Environmental Impact Report

LDR No. 99-0618
SCH No. 1984030708

SUBJECT: SeaWorld Master Plan Update. SEAWORLD MASTER PLAN UPDATE, MISSION BAY PARK MASTER PLAN UPDATE/LOCAL COASTAL PROGRAM LAND USE PLAN AMENDMENT, and PROGRESS GUIDE AND GENERAL PLAN AMENDMENT to allow an increase of the height limit on the existing 189.4-acre SeaWorld leasehold from 30 feet to a maximum of 160 feet, in order to implement the approved SeaWorld Initiative, Proposition D. The SeaWorld Master Plan Update proposes locations within the theme park area where taller structures could be developed with exhibits, rides, or shows as well as an extensive renovation of the front gate area. One particular area is designated for development as a "Splash-Down" ride. Other structures within the SeaWorld leasehold but outside the theme park proposed to exceed 30 feet in height would include a hotel, an Educational Facility, the Special Events Center expansion, and a parking structure. The project also proposes expansion of the SeaWorld Marina (formerly "Perez Cove" Marina) and would allow for additional future redevelopment throughout the leasehold. The project site is located on SeaWorld Drive, east of Ingraham Str

Figure 4.2-32

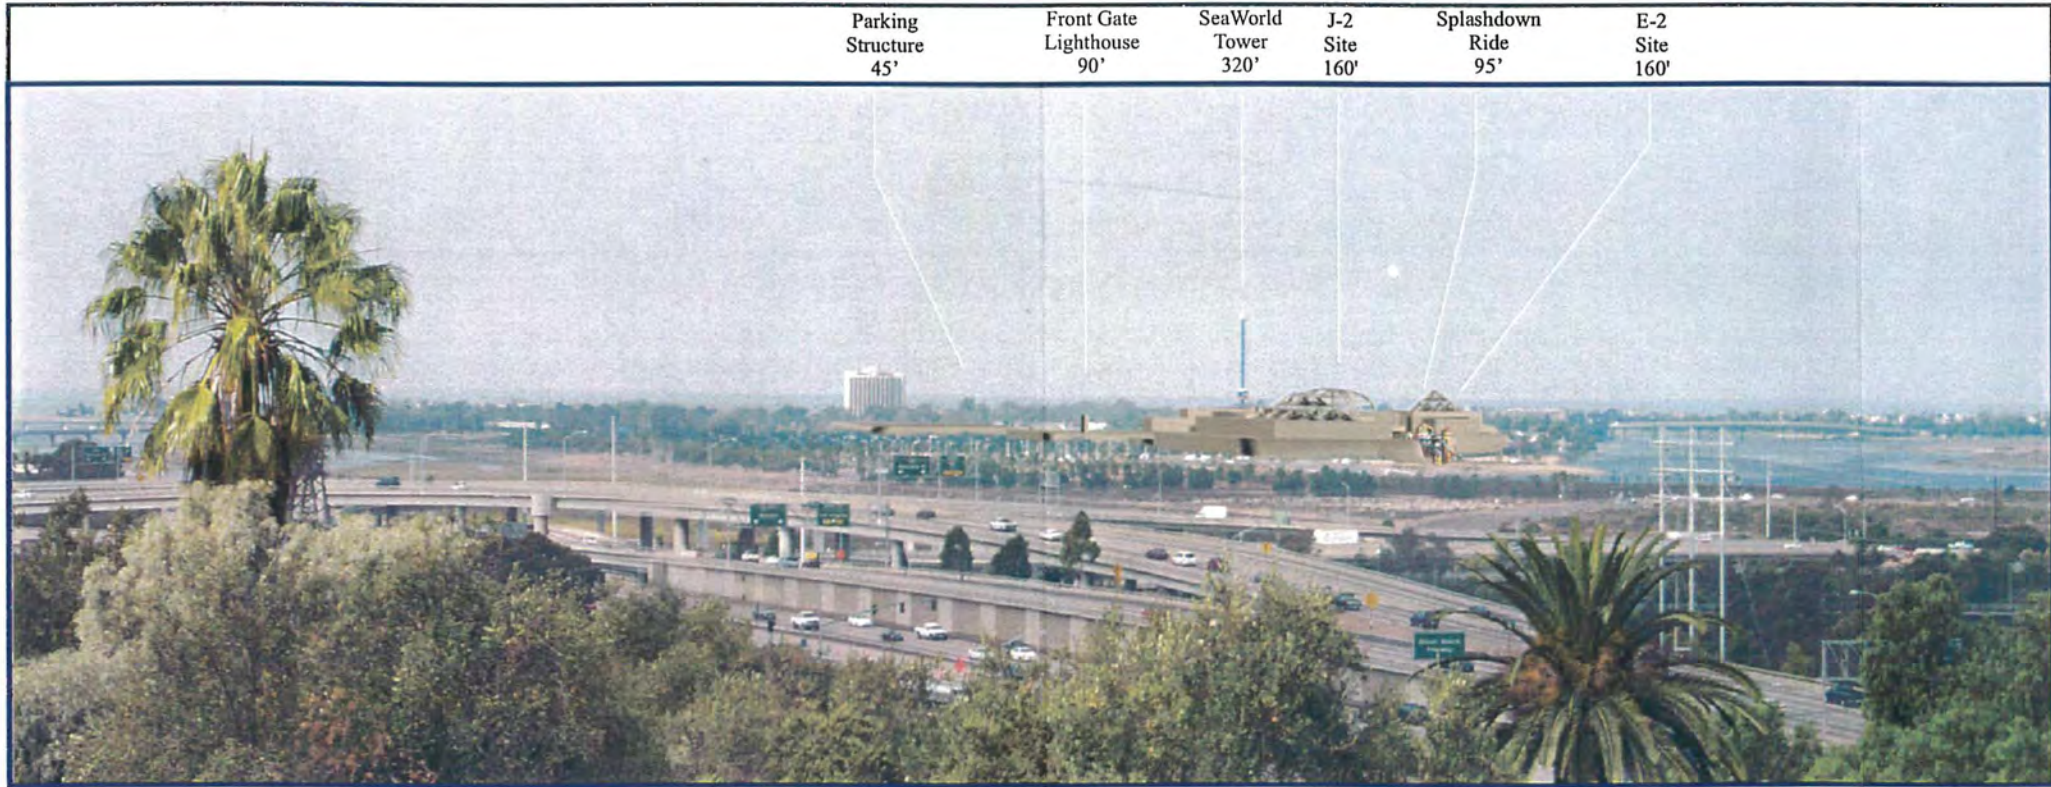
I-606	As one can see from the Photosimulation of Maximum Potential Buildout Mass from West Mission Bay Bridge, KVP-3 (SWMPU, Draft EIR, Figure 4.2-32), the potential buildout would totally destroy this view of Mount Soledad from this Bridge.. With the proposed Area 2 View Corridor (see Exhibit 3), with a height limit of 60 feet (or 45 feet), a portion of this view would be realized. (See Exhibit 4, Picture B.)	I-606	See response to comment I-600.
I-607		I-607	See response to comment I-599.
I-608	This proposed View Corridor Area 2, would allow a significant portion of the view to be seen from KVP-3 while having minimal impact on the overall project. Only Exhibit Areas J-2, L-2, and C-1 would entirely be affected, and Areas E-2, G-2, and H-2 would be slightly be affected on their perimeters.	I-608	See response to comment I-599.
I-609	Of these, L-2 is a proposed children's area with less need for height than other areas, so the limitation of 60 feet would have little consequences on the development of this area.	I-609	See response to comment I-599.

Approximate Limits of Mission Bay Landfill (Revised) _____ Figure 4.11-1

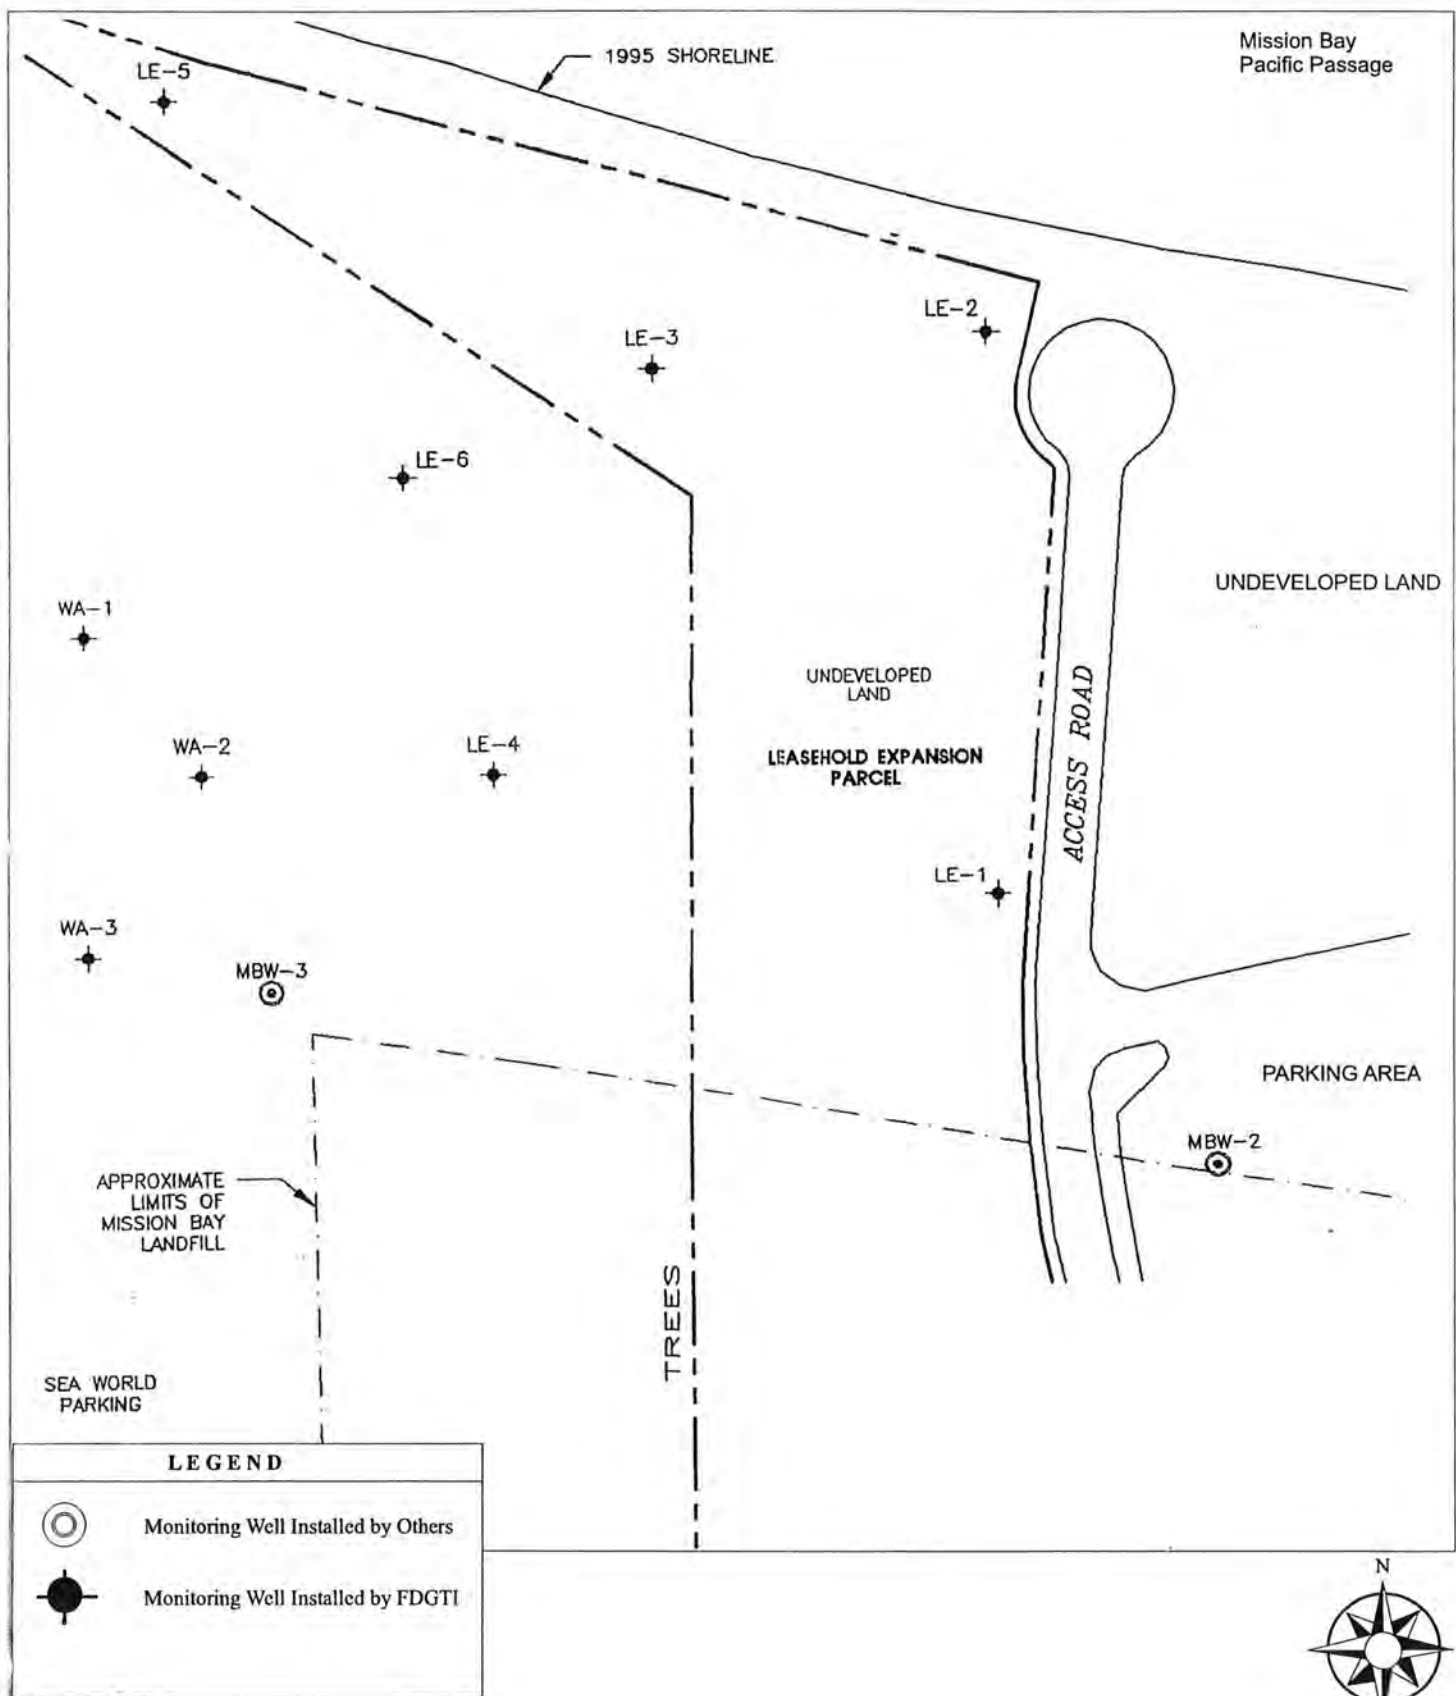
I-477 This comment is correct in that the southeast corner of the SeaWorld leasehold includes the inactive Mission Bay Landfill and that a small portion of the revised approximate landfill boundary map (See revised Figure 4.11-1 in the Draft EIR) does overlay the southeast corner of Site I-2 of the Tier 2 projects. See responses to comments S-1, S-2 and S-7.

I-495 The landfill boundary has been removed from Figures 3.4-1 and 3.4-2, and Figure 4.11-1 in the Draft EIR has been revised to include the most current approximate landfill boundary on the SeaWorld leasehold prepared by the City of San Diego, Department of Environmental Services. See responses to comments S-1, S-2, S-7 and S-17.
